**RE: Supplementary Information Provided for Request to Dispose of
Contaminated Soils Underground at Lupin**

**SUPPLEMENTARY INFORMATION:
REQUEST FOR APPROVAL TO DISPOSE OF
CONTAMINATED SOILS UNDERGROUND AT LUPIN MINE**

WATER LICENCE NWB1LUP0008

LUPIN MINE, Nunavut

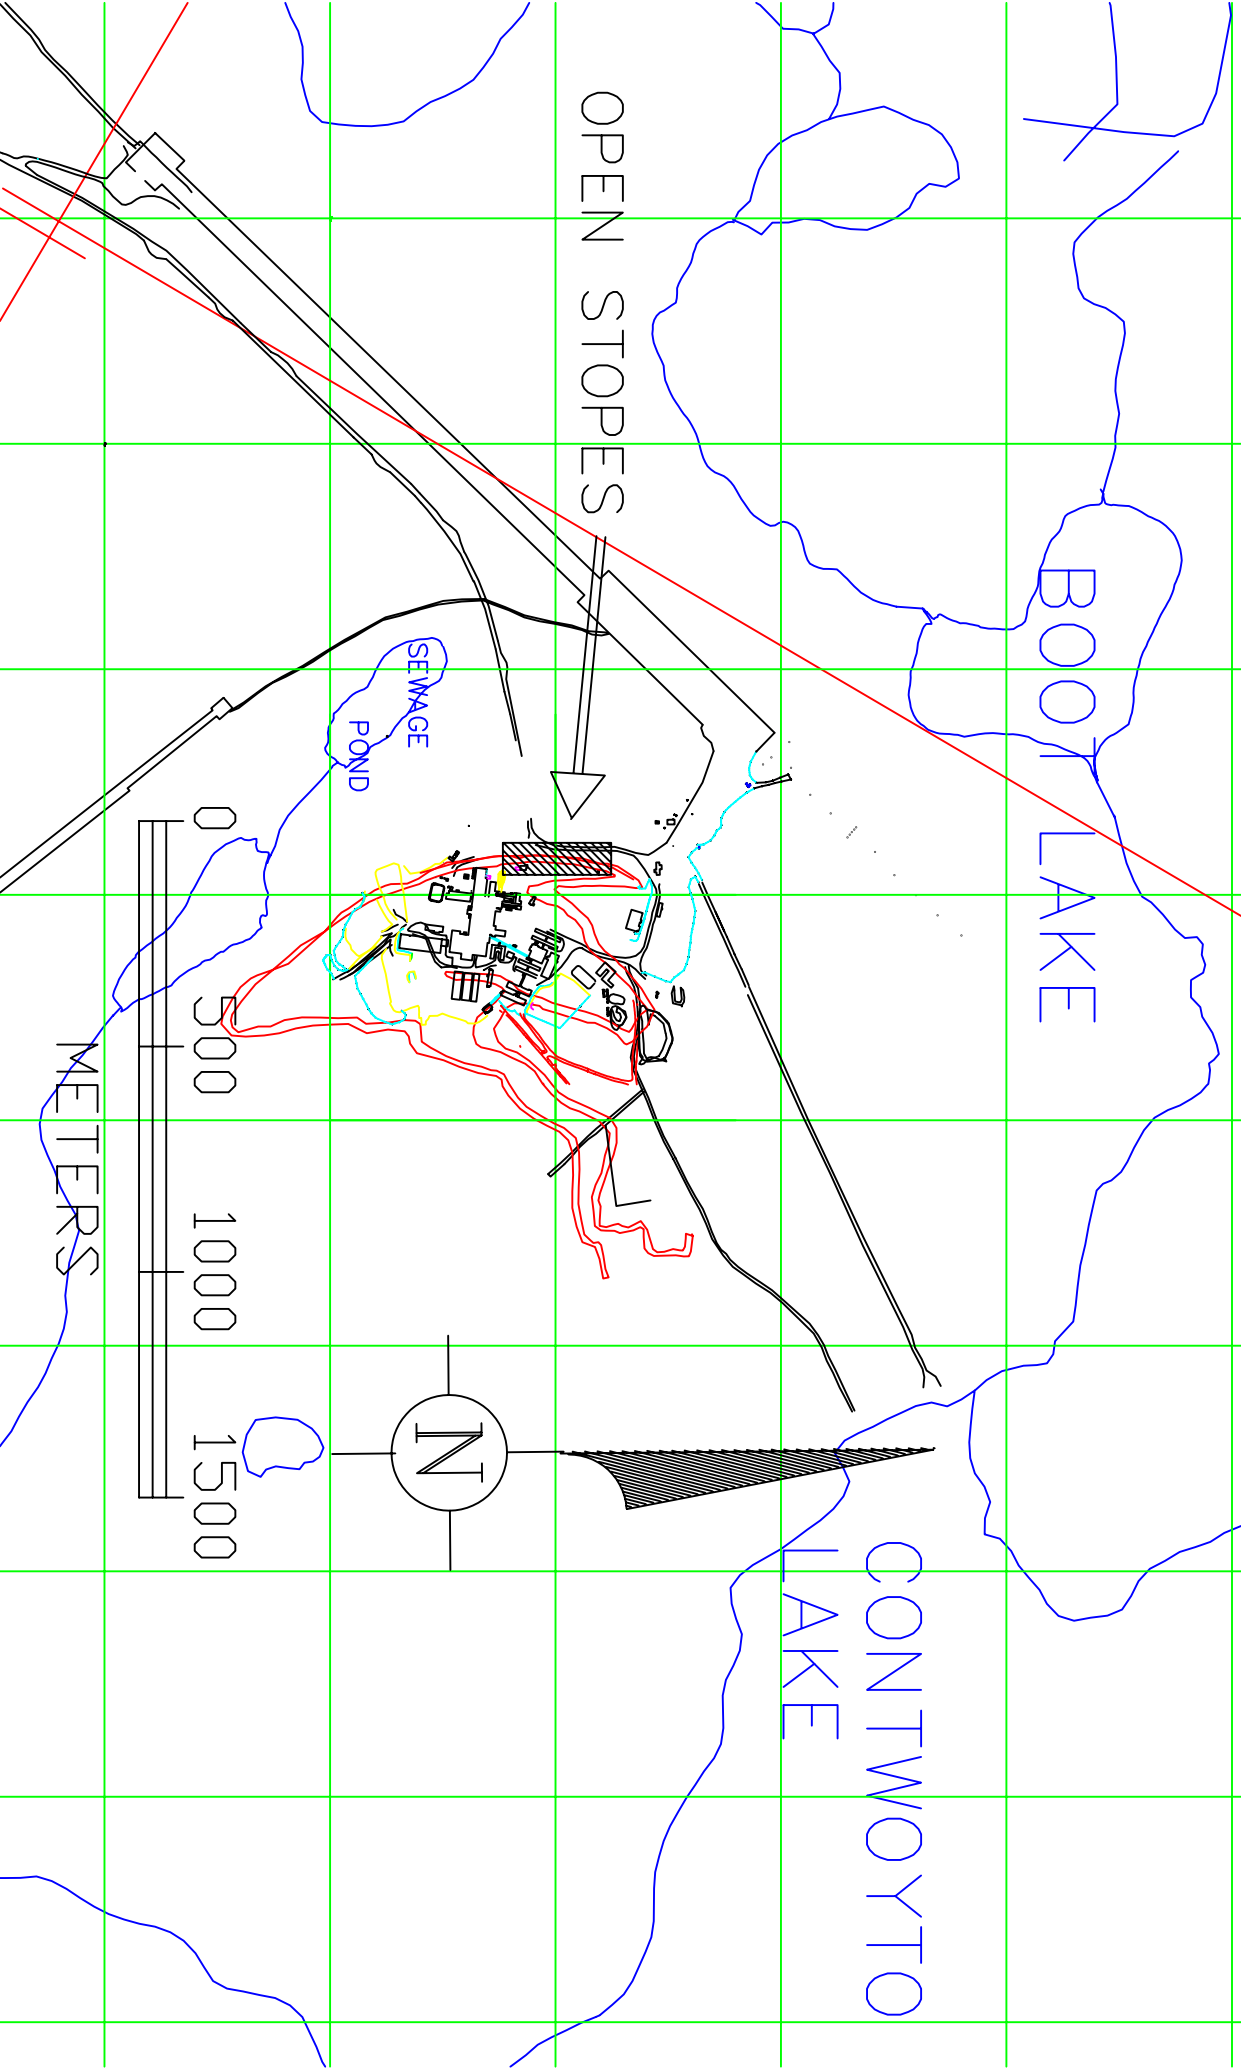
Comment: *What are the depths of the stopes proposed for use? What volume of contaminated soils can the stopes contain? How will the material be placed? Indicate location of stopes in relation to any water bodies.*

As shown on the attached area plan, the closest body of water to the open stope location is the upper sewage pond, approximately 400 metres to the south. The closest body of fresh water to the open stope location is Boot Lake, approximately 800 metres to the west. Contwoyto Lake is located approximately 1400 metres northeast.
